## Addendum to User's Manual 250-0225

Document no. 250-0225a

Figure 8. DISABLE/ENABLE Terminals

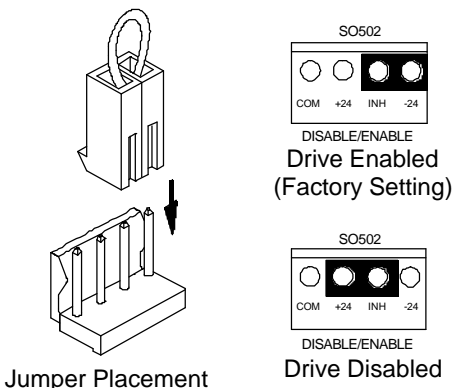
Due to an error which was not caught until after the print run was completed, Figure 8 in the manual is illegible. The correct illustration is shown below.
